Access Compliance Report

Public Rights-of-Way

Intersection ID: 45138	Main Street: ASHER_CT	Cross Street: FOUR SISTERS_LN	Location: NW
ADA ID: E1CC9C1D0709	Ramp Type: PerpDiag	Initial Pass/Fail: Fail	Overall Compliance: No
		Severity Score: 17.5

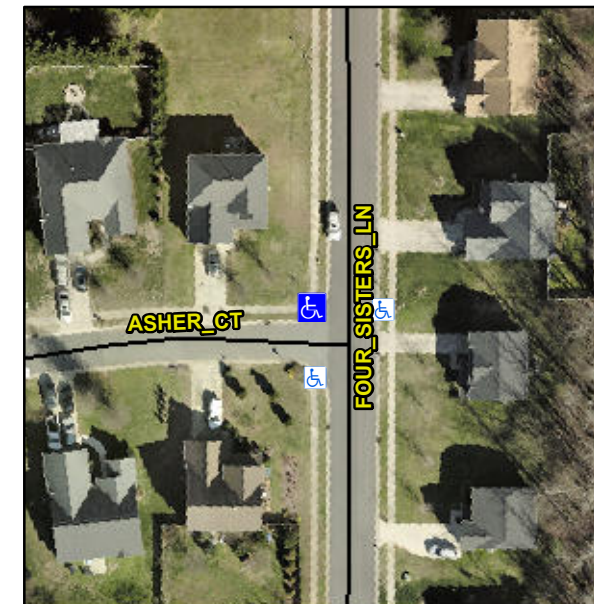
Not Found, R304.5.1

Remove & Replace Curb Ramp With Two New Directional Ramps or Equivalent.
